Independent Verification Memo — Pump Module WO-01 Supplier Qualification

This memo recomputes the WO-01 pump-module decision independently from the trusted source table and cross-checks the proposal author's report against it. All four candidates pass both policy gates, so qualification is unanimous. On the shared acceptance-run basis the verified energy order is P2 at 12 kWh, P3 at 52, P1 at 56 and P4 at 58, giving gaps to the winner of 40, 44 and 46 kWh. P2 clears both gates with the field's highest quality (97) and one defect. The author's gate arithmetic, ranking, gap figures and policy reading all reproduce exactly from the table; no invented measurements were found. Cost, delivery, maintenance and field reliability remain unverified and stay excluded. My independent ballot is P2.

Verification diagram: gate status and measured energy per candidate, with dashed gap markers showing computed shortfalls of 40, 44 and 46 kWh to P2 on the common basis.

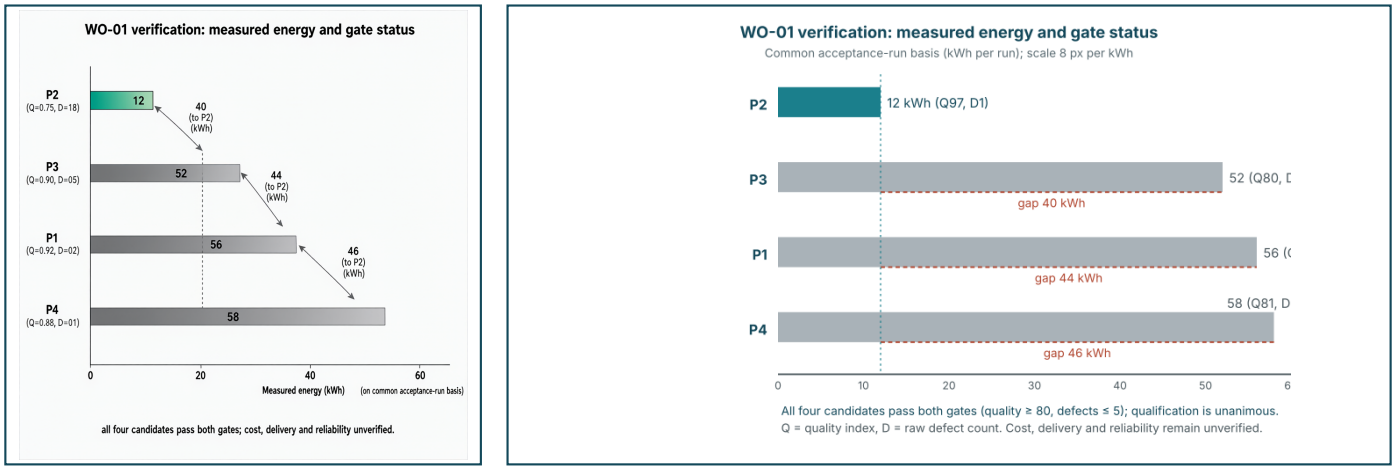
All energy values share the same output, load and acceptance-run basis, so the column is directly comparable. The verified order is P2 at 12 kWh, P3 at 52, P1 at 56 and P4 at 58. Recomputed gaps to the winner: P3 52−12 = 40 kWh; P1 56−12 = 44 kWh; P4 58−12 = 46 kWh. Even substantial uncertainty in a single run could not plausibly close a 40 kWh spread, so the ordering is robust on the supplied facts.
